# **NEIGHBORHOOD SAMPLING PLAN**

Riverside Neighborhood Evaluation  
Riverside, California 92503

Department of Toxic Substances Control  
Brownfields Restoration and School Evaluation Branch  
Greg Sweel, P.G., Senior Geologist  
Amit Pathak, P.E., Project Manager  
Loveriza Sarmiento, Ph.D., Toxicologist  
5796 Corporate Avenue  
Cypress, California 90630  
714.484.5300

<b>APPENDICES</b>		<b>Page</b>
Appendix A	CARB Procedures to Calculate PCB Emissions from Ag Park .....	33
Appendix B	CARB Air Dispersion Modeling Results .....	39
Appendix C	Hazard Appraisal and Recognition Plan .....	48
Appendix D	Response to Comments Table.....	51

Figure 2 - Properties selected for sampling

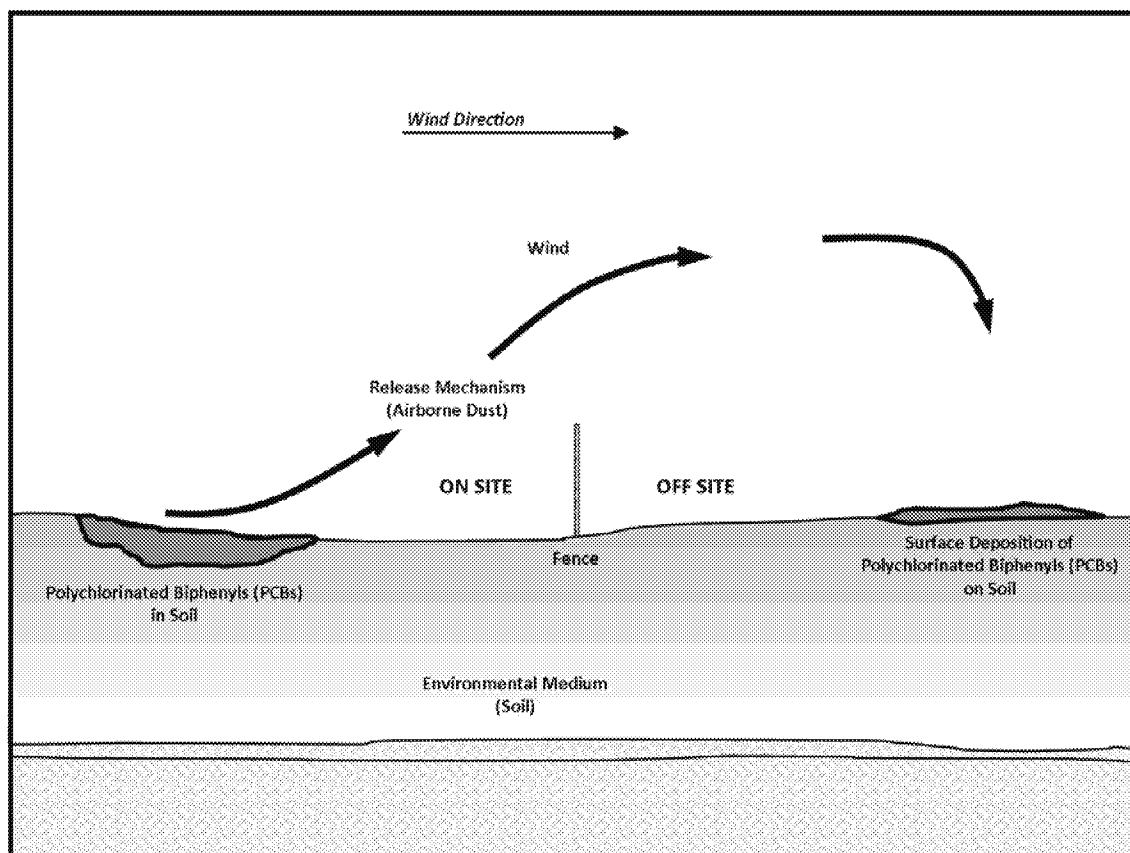
Figure 2 (Properties selected for Sampling) on Page 21 identifies the 28 residential properties from which soil samples will be collected. Similar to the comments provided on December 16, 2016 during a briefing on the preliminary Neighborhood Sampling Plan, and similar to the comments submitted on January 17, 2017, City staff again reiterates the need to include five additional properties within the scope of the Draft Neighborhood Sampling Plan. The three residential properties on the westerly side of Crest Avenue between Mandalay Court and Jurupa Avenue that are not currently included need to be included as well as the two residential properties on the westerly side of Crest Avenue between Chula Vista Way and Ontario Street. Given that these residences are nearly adjacent to Ag Park and that the model generally identifies this area as “most impacted” (or more likely soil could be deposited than other areas), the City recommends that testing also be conducted on these additional properties.

DTSC has identified the sampling properties based on the areas predicted to have the highest potential concentrations (shown in orange color) by the air dispersion model. The City property east of Crest Avenue (Figure 2) was selected based on the air dispersion modeling output.

The three selected properties for sampling, west of Crest Avenue (Figure 2), are based on community feedback and the City’s initial feedback we received during our meeting with the City on December 16, 2016. While we appreciate the City’s desire for adding additional properties to the sampling plan scope of work, we will initiate sampling with the properties identified in the sampling plan at this time. Please keep in mind that sampling may be expanded to other properties, including those recommended by the City, based on results from the initial sampling.
